ADDENDUM NO. 1

for CSP #250086

Org 208 Seagoville Elementary School – Addition and Renovation

Dallas Independent School District
April 27, 2026

01 FIRST FLOOR FRAMING PLAN - AREA D
SCALE: 3/16"=1'-0"

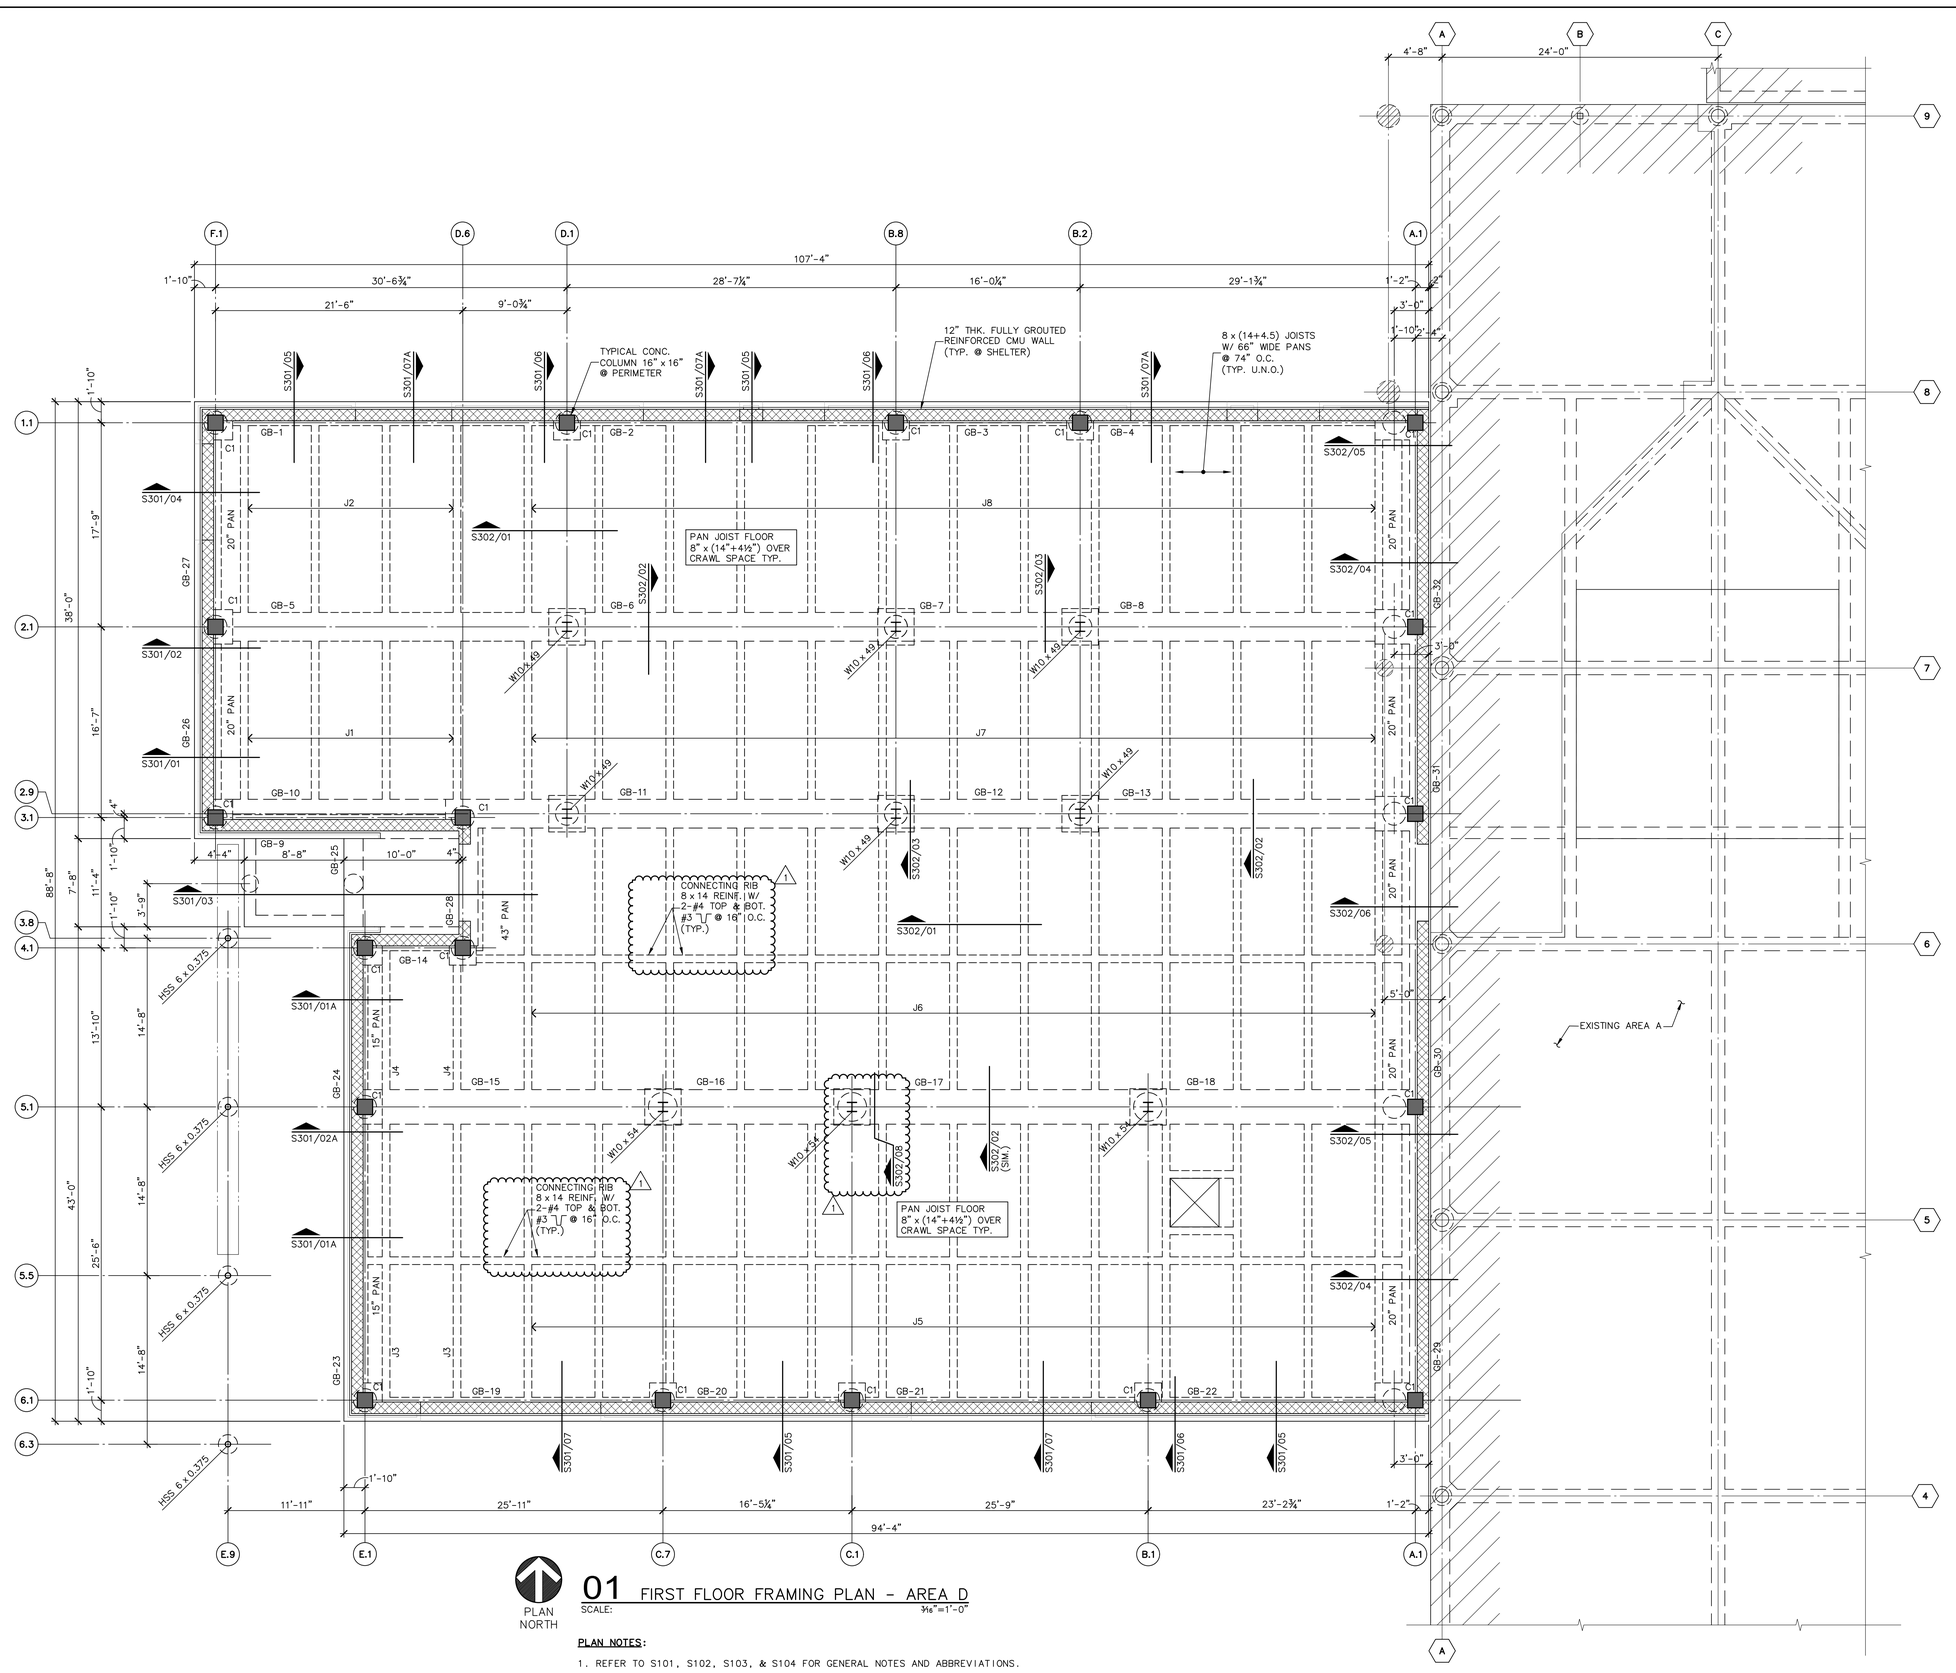
ITEM NO.32 S201 FIRST FLOOR FRAMING PLAN – AREA D

1. Provided enlarged plan details for framing connection reference.
2. Provided additional notes to connecting RIB notes.

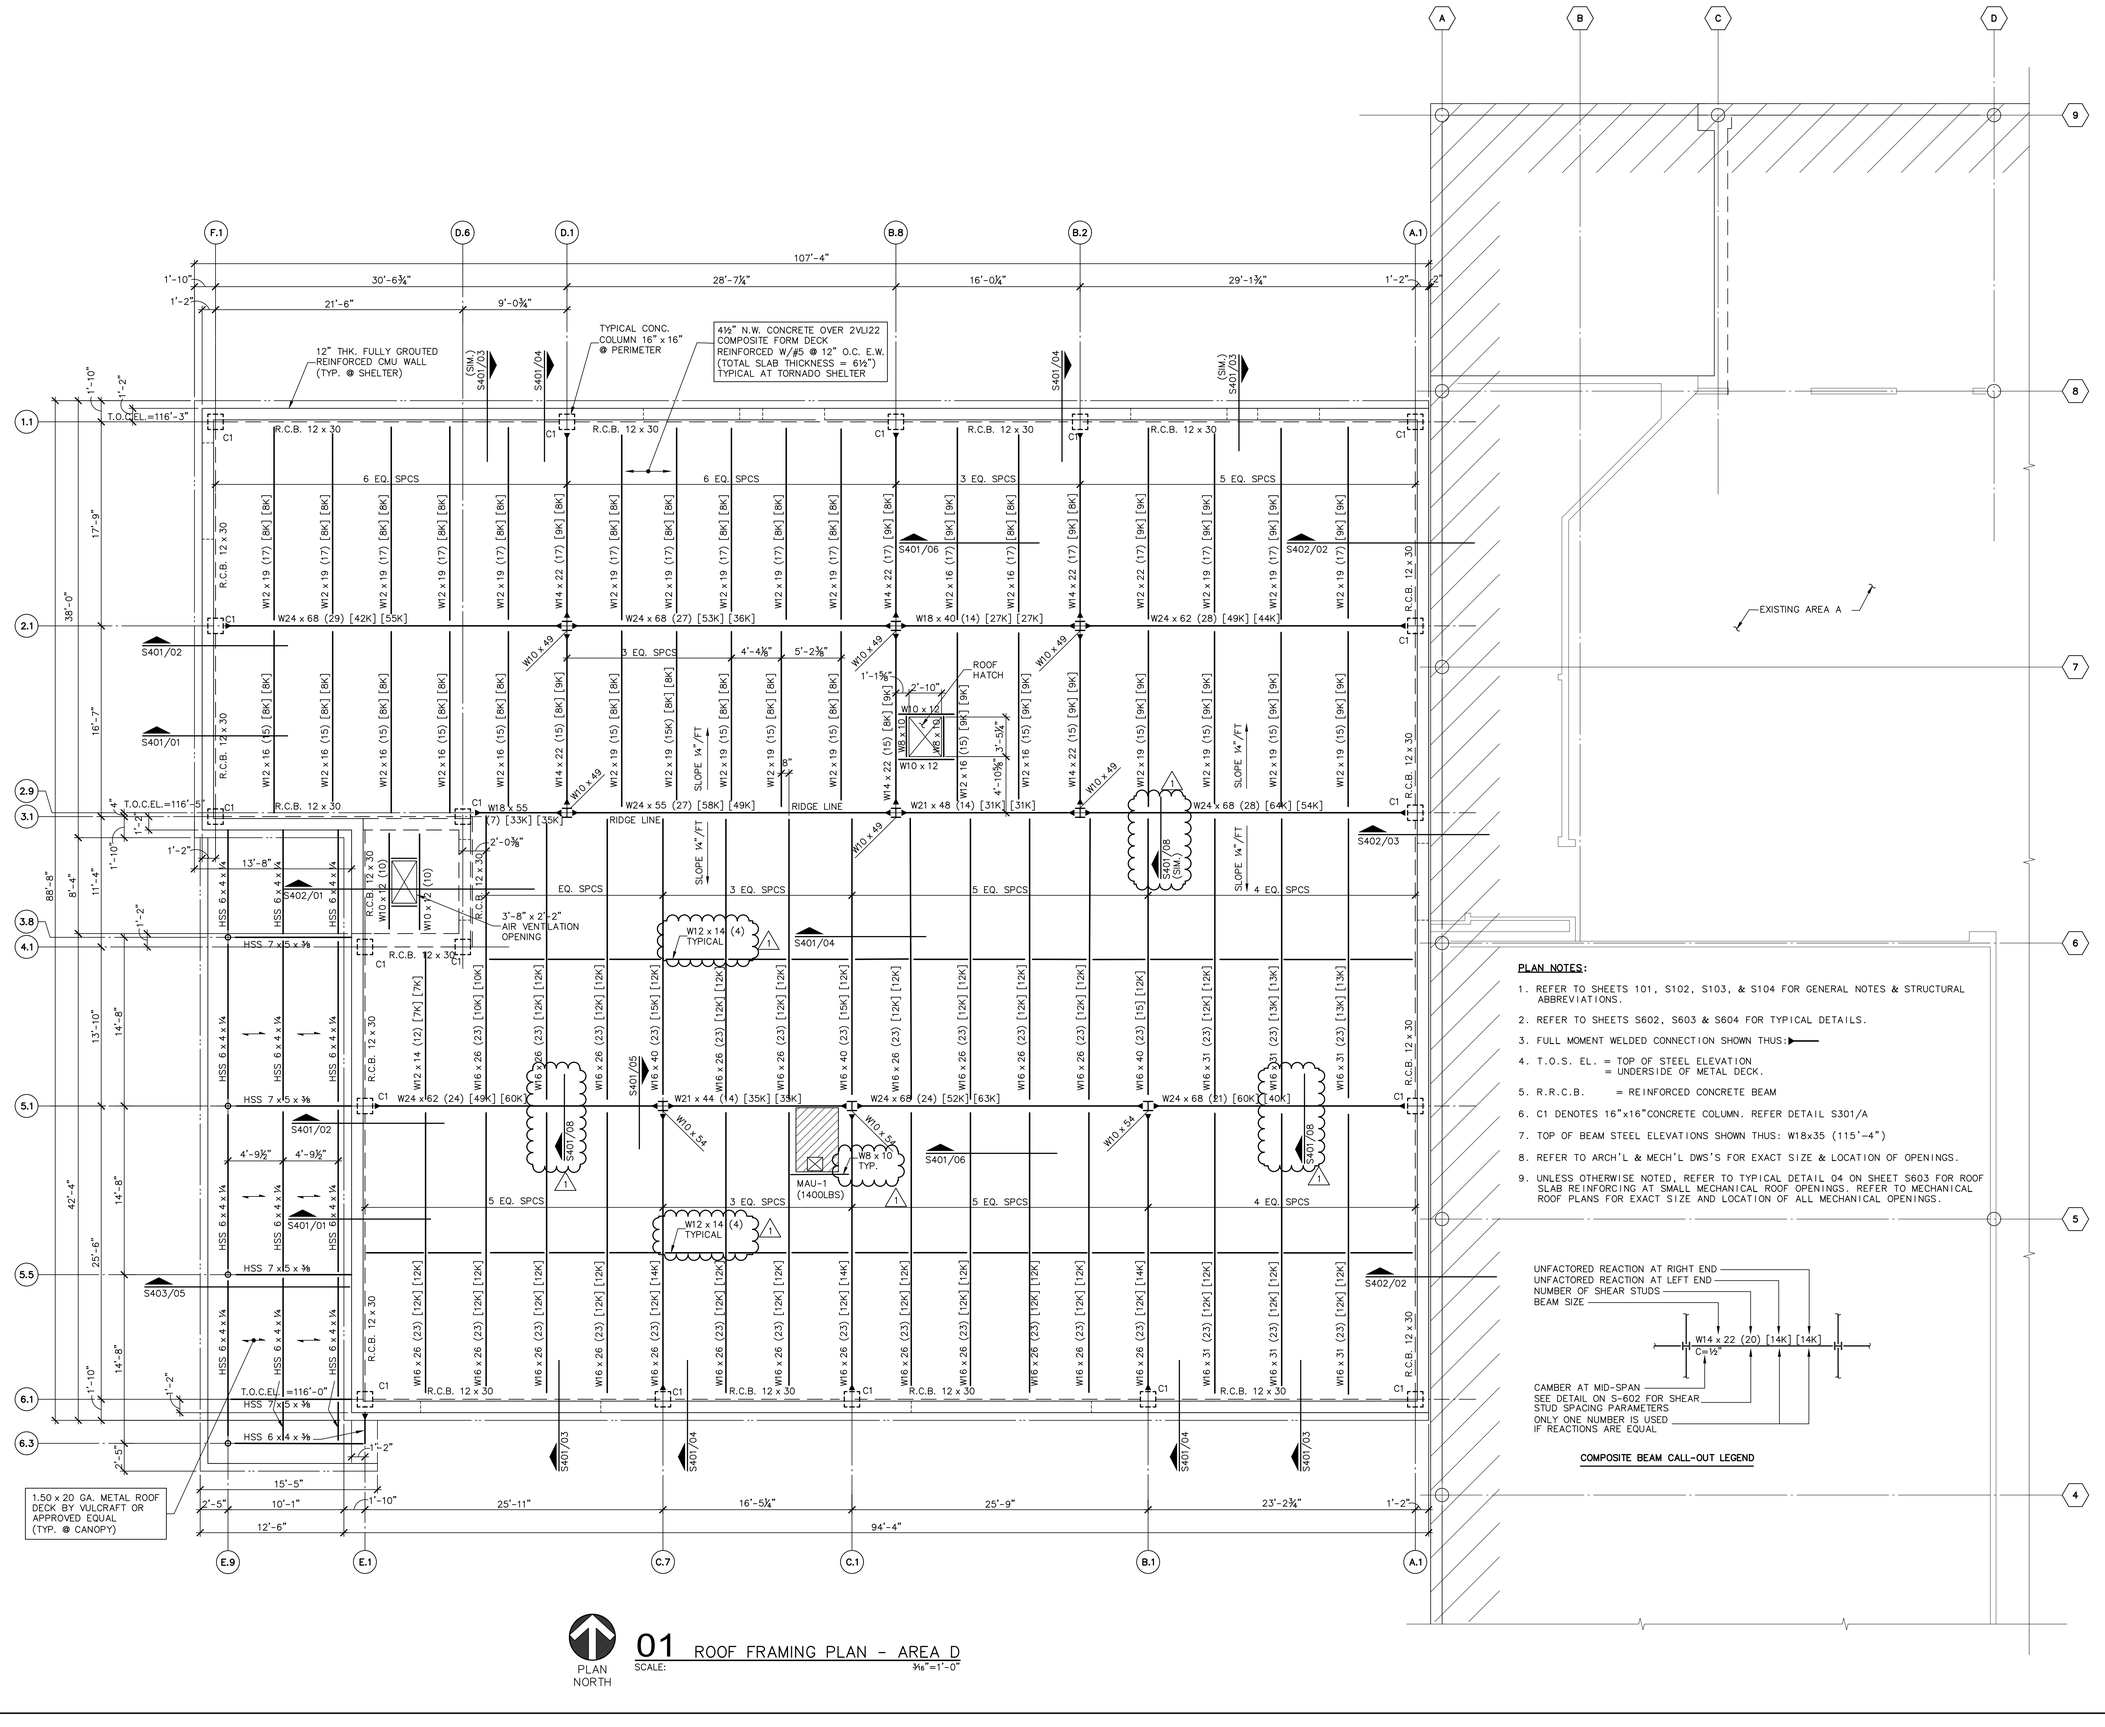
ITEM NO. 2 Question 2: Sheet S202 does not provide respective section cuts that show typical Wide Flange Beam connections to the 12"x30" concrete beam as shown on details 1 & 3 on S401. Please provide information on the required embed plates or connections at these locations where a vertical concrete column (C1) does not occur. Additionally, detail 2 on S402 provides a statement that "wide flange beam and connection are not shown for clarity" please advise where the wide flange beam and connection are shown.

ITEM NO.33 S202 ROOF FRAMING PLAN – AREA D

1. Provided enlarged plan details for framing connection reference.
2. Added additional framing note clarification

Response: Refer to updated Sheet S202 reference to Sheet S401 Detail 01 & 03 updated. Additionally refer to Sheet S402 Detail 02 updated.

1 M-501 Mechanical Roof Plan
SCALE: 1/8" = 1'-0"

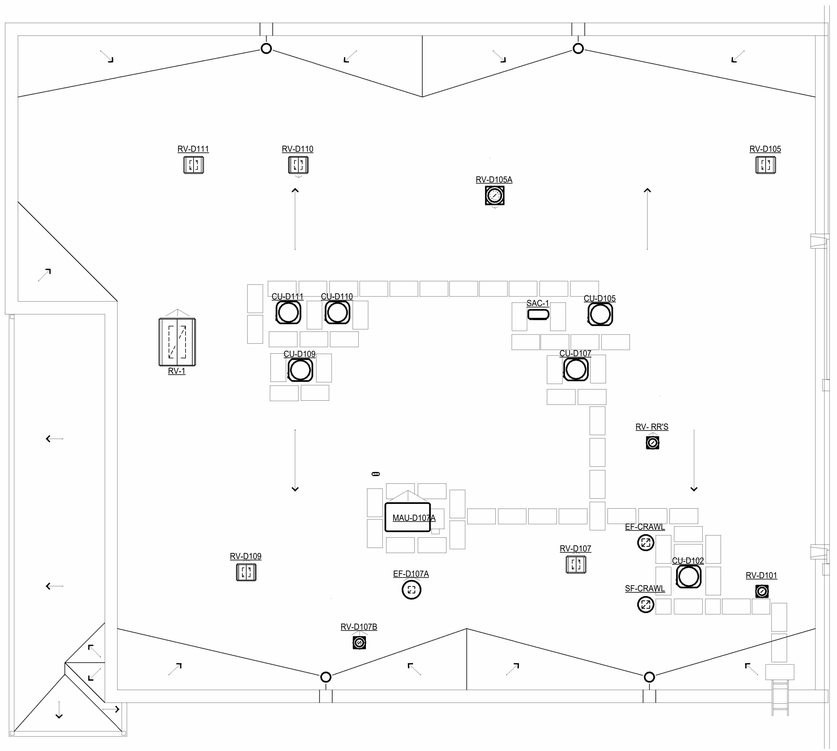
ITEM NO. 3 M-501 – MECHANCIAL ROOF PLAN

1. **CHANGE** – Roof plan updated to show the removal of the Secondary Roof drains and replacement with overflow scuffers.

4 P-101 STORM PIPING RISER
SCALE:

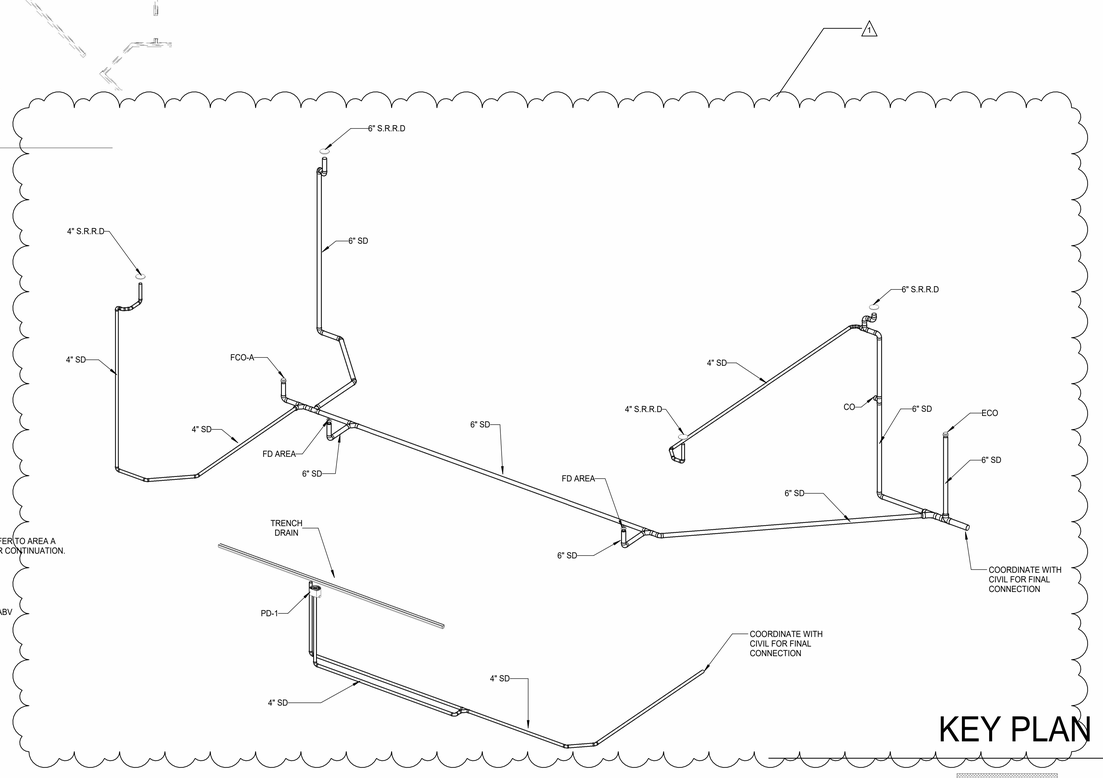
ITEM NO. 5 P-101 – PLUMBING SANITARY PLAN – FOUNDATION

1. **DELETE** – 6” SSD, 6” SDN, 6” S.R.O.F.D, 4” SDN, & 4” S.R.O.F.D. from detail 4 Storm Piping Riser diagram.

1 / P-201 LEVEL 1 - SANITARY AND STORM FLOOR PLAN AREA D
SCALE: 1/8" = 1'-0"

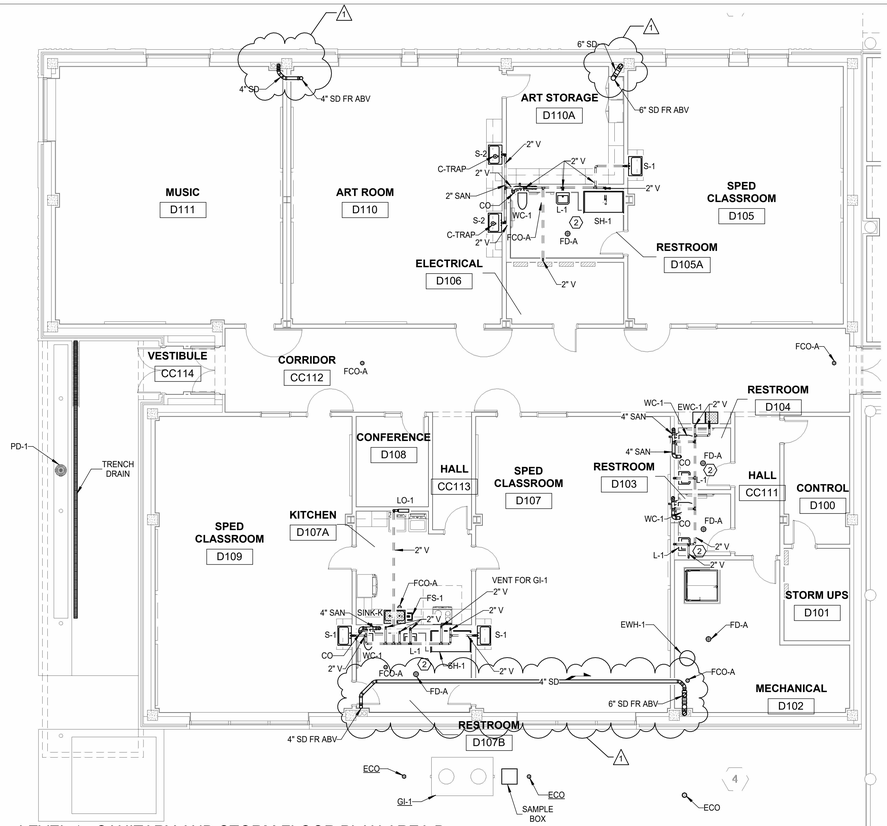
ITEM NO. 6 P-201 – PLUMBING SANITARY AND STORM PLAN

1. **DELETE** – 6” SDN, 6” SSD, 6” SSD FR ABV, 4” SDN, 4” SSD, & 4” SSD FR ABV from detail 1 Level 1 – Sanitary and Storm Floor Plan Area D.

1 P-202 PLUMBING ROOF PLAN
SCALE: 1/8" = 1'-0"

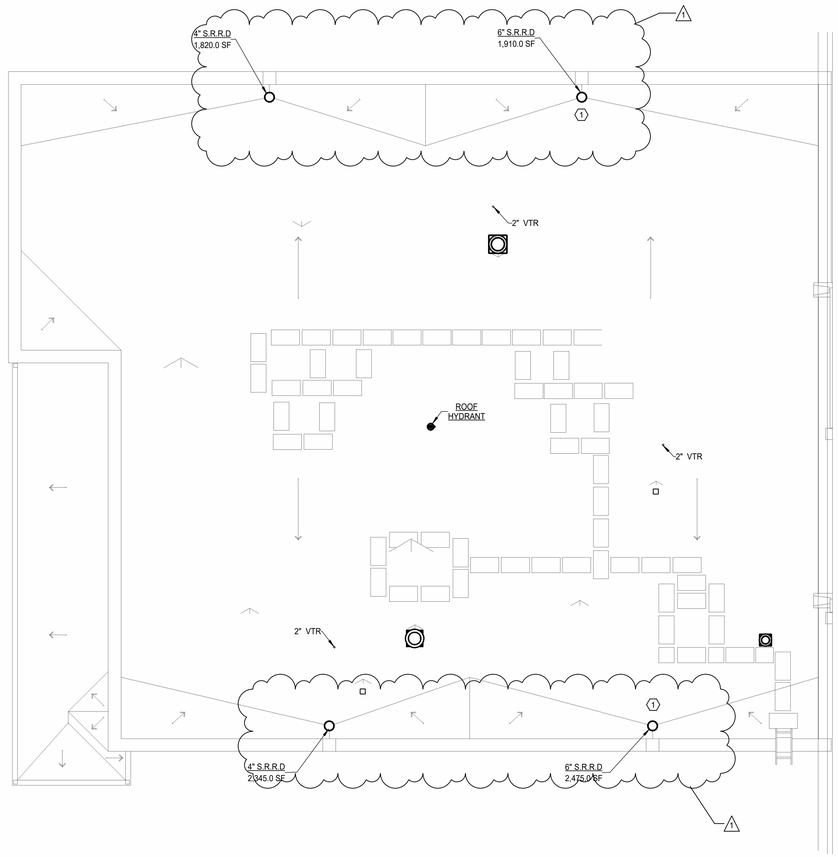
ITEM NO. 7 P-202 – PLUMBING ROOF PLAN

1. **DELETE** – 6” S.R.O.F.D. & 4” S.R.O.F.D. from detail 1 Plumbing Roof Plan.
